THURBER ENGINEERING LTD.

MEMORANDUM

**FOUNDATION ENGINEERING CHANGE ORDER 5
HIGHWAY 11 CULVERT REHABILITATION (SITE NO. 42X- 194/C0)
NORTHEASTERN REGION**

AGREEMENT NO. 5017-E-0003

CONT No
GWP No 5158-12-01
HIGHWAY 11 TRENCHLESS
CULVERT REPLACEMENTS
CULVERT 42-194/00
MONITORING LOCATION PLAN

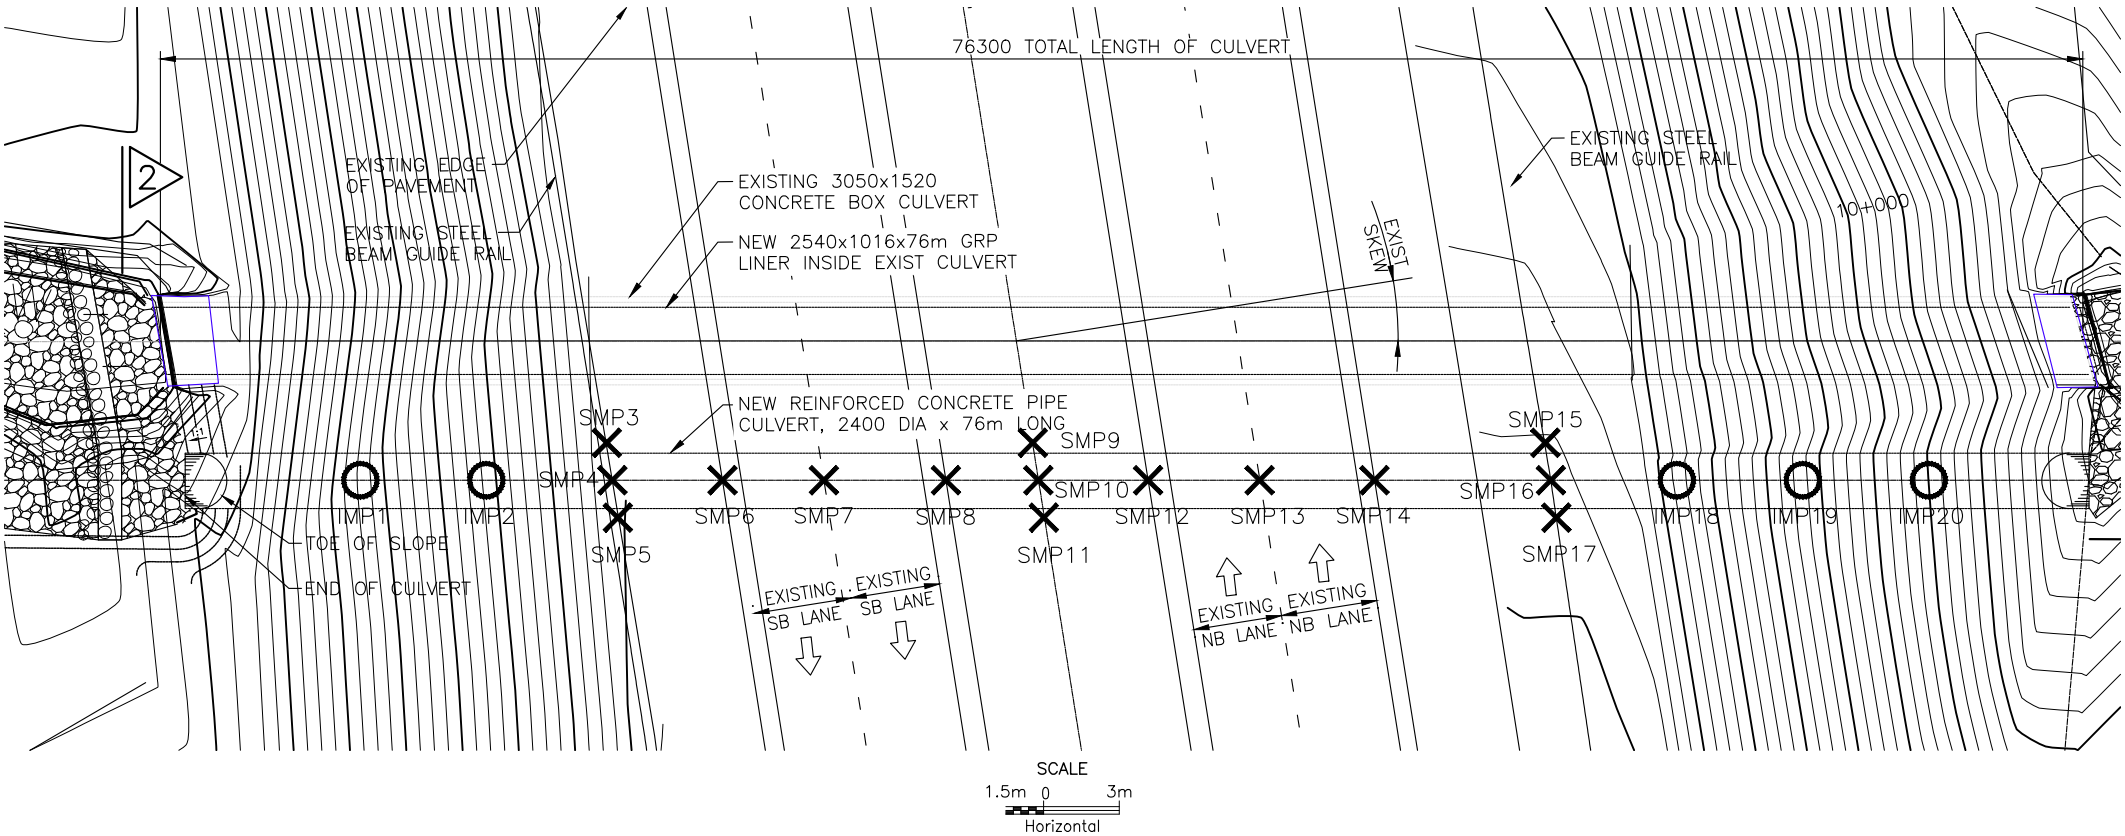
**** The Contractor shall furnish, install and monitor Surface Settlement Monitoring Points (SMP) and In Ground Settlement Monitoring Points (IMP) at the locations shown in the Contract Package and in accordance with Section 7.07 of Pipe Installation by Trenchless Methods.
